PARKING BRAKE OVERRULE TANK SUPPORT - RETROFIT Prevost vehicles

For the vehicles affected by this bulletin, reinforced parking brake overrule tank supports are available.

NOTICE TO SERVICE CENTERS	
Verify vehicle eligibility by checking warranty bulletin status with SAP or Vehicle Warranty Information tool found on Prevost-Systems tab of the Volvo Trucks Dealer Portal	
Model	VIN
NYCTA X3-45 Commuter Model Year : 2012	From 2PCG33495CC73 <u>5053</u> up to 2PCG33495CC73 <u>5232</u> incl.
This bulletin does not necessarily apply to all the above-mentioned vehicles, some vehicles may have been modified before delivery. The owners of the vehicles affected by this bulletin will be advised by a letter indicating the Vehicle Identification Number (VIN) of each vehicle concerned.

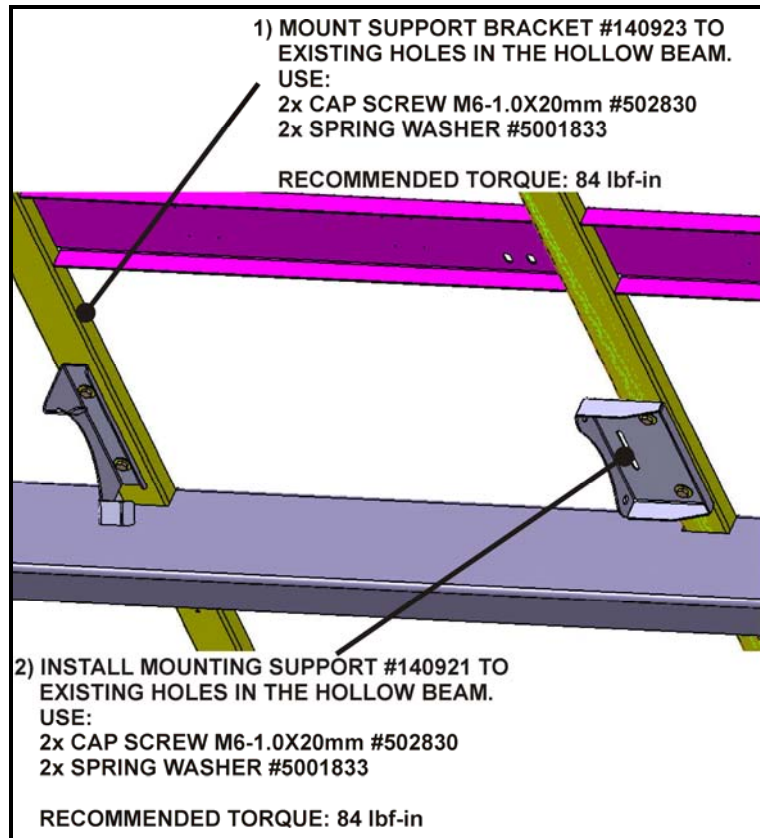
- 1) Open the last L.H. side baggage compartment.
- 2) Place two appropriate jack stands under the parking brake overrule tank at about 12 inches from the tank.
- 3) Undo and discard the two t-bolt band clamps. Rest the tank on the jack stands.
- 4) Remove and discard the existing support brackets and mounting supports.
- 5) Preassemble the parking brake overrule tank as described on the image at right.

- 6) Mount the support bracket and the mounting support as described on the image at right.

CAP SCREW TORQUE: 84 lbf-in

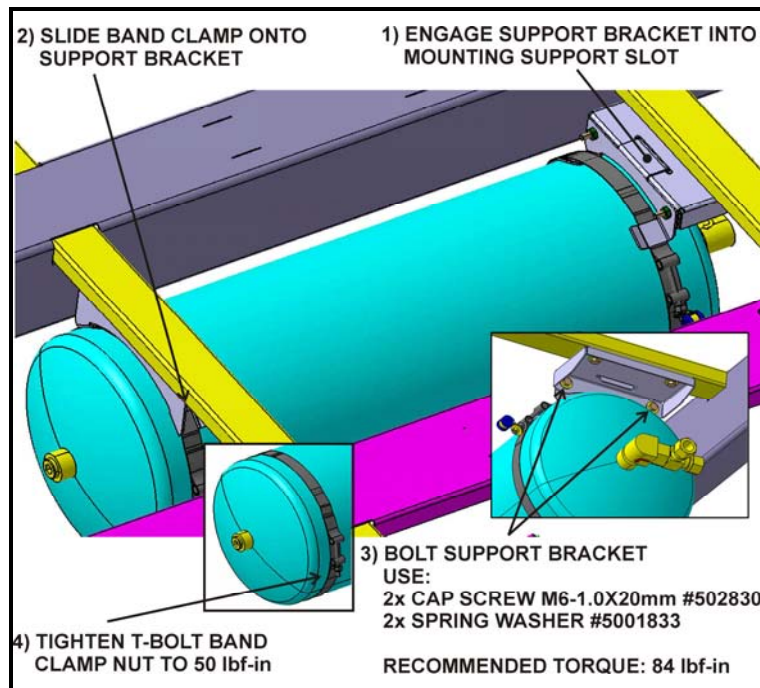
- 7) Mount the parking brake overrule tank onto the vehicle chassis as described on the image at right.
